UNITED STATES PATENT AND TRADEMARK OFFICE

APPLICATION NO.	FILING DATE	FIRST NAMED INVENTOR	ATTORNEY DOCKET NO.	CONFIRMATION NO.
10/535,560	05/17/2006	Toshihisa Hirata	A3-205 US	7492

Office Action Summary

DETAILED ACTION

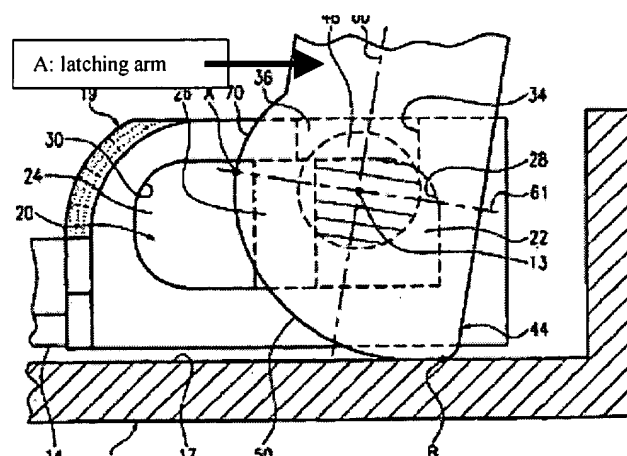
In regards to claim 2, Rumpel et al discloses the memory card connector (1) wherein the pivot means (of 28) of the pivot-detent mechanism (of 20+48) comprises a pivot socket (28) in one of the housing (11) for receiving a pivot projection (48) on the cover (12).

In regards to claim 3, Rumpel et al discloses the memory card connector (1) wherein the detent means (of 30) of the pivot-detent mechanism (of 20+48) includes a detent socket (30) separate from and independent of the pivot socket (28) (by the rib 26) for receiving the pivot projection (48) and defining the latched position of the cover (12), the pivot projection (48) thereby performing a dual (pivot and sliding/latching) function of forming a portion of both the pivot means (of 28) and the detent means (of 30).

In regards to claim 4, Rumpel et al discloses the memory card connector including complementary interengaging latch means (of A) between the sidewalls of the cover (12) and opposite sides of the housing (11) and automatically engageable when the cover (12) slides to the latched position (24).

In regards to claim 6, Rumpel et al discloses the memory card connector (1) wherein the housing (11) is generally flat and mounts the terminals (col. 3, lines 3-13) in a generally side-by-side array (it is inherent, see EP 0 472 692 or US5996891) and includes a pair of mounting portions (19) at opposite sides thereof, the pivot-detent mechanism (of 20+48) being operatively associated between the mounting portions (19) and the cover (12).

In regards to claim 7, Rumpel et al discloses the memory card connector (1) wherein the cover (12) is generally flat and the receptacle means (holding means) includes a mouth (adjacent 46) at one end of the cover (12) for insertion of the memory (SIM) card thereinto, the cover (12) having a pair of spring arms (A) at an opposite end thereof and juxtaposed alongside the pair of mounting portions (19) of the housing (11), the pivot-detent mechanism (of 20+48) being operatively associated between the mounting portions (19) of the housing (11) and the spring arms (A) of the cover (12) (see marked-up below).

In regards to claim 8, Rumpel et al discloses the memory card connector (1) wherein the pivot means (of 28) of the pivot-detent mechanism (of 20+48) comprises a pivot socket (28) in each of the mounting portions (19) of the housing (11) for receiving a pivot projection (48) on each of the spring arms (A) of the cover (12).

In regards to claim 9, Rumpel et al discloses the memory card connector (1) wherein the detent means (of 30) of the pivot-detent mechanism (of 20+48) includes a detent socket (30) in each of the mounting portions (19) of the housing (11) separate from and independent of the pivot socket (28) in the respective mounting portion (19), the detent sockets (30) receiving the pivot projections (48) and defining the latched position of the cover (12), and the pivot projections (48) thereby performing a dual (pivot and latching/sliding) function of forming a portion of both the pivot means (of 28) and the detent means (of 30).

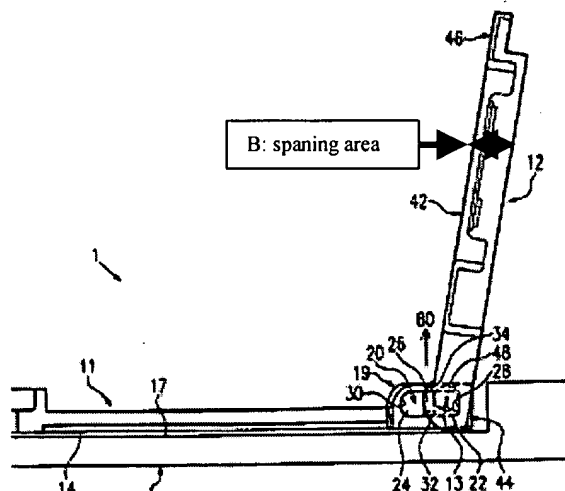
In regards to claim 12, Rumpel et al discloses the memory card connector wherein the spring arms (A) are resilient to self-bias the pivot projections (48) thereon into the pivot sockets (28) and the detent sockets (30) in the mounting portions (19) of the housing (11). Rumpel et al discloses the invention generally all as claimed, but lacks a stamped, sheet metal cover.

However, Schnell et al teach the cover (17) is a stamped and formed of a sheet metal material (col. 3, lines 22-23). It would have been obvious to one having ordinary skill at the invention was made to modified the cover of Rumpel et al by having a stamp, sheet metal material as taught by Schnell et al for increasing the flexibility of the latching arms.

In regards to claim 13, Rumpel et al discloses the memory card connector wherein the cover (12) includes a cover (top) plate (of 12) spanning an area between the spring arms (A) and a pair of sidewalls (B) defining opposite sides of the receptacle means (holding means) (see marked-up above). Claim 14 is rejected for the same reason as claim 4.
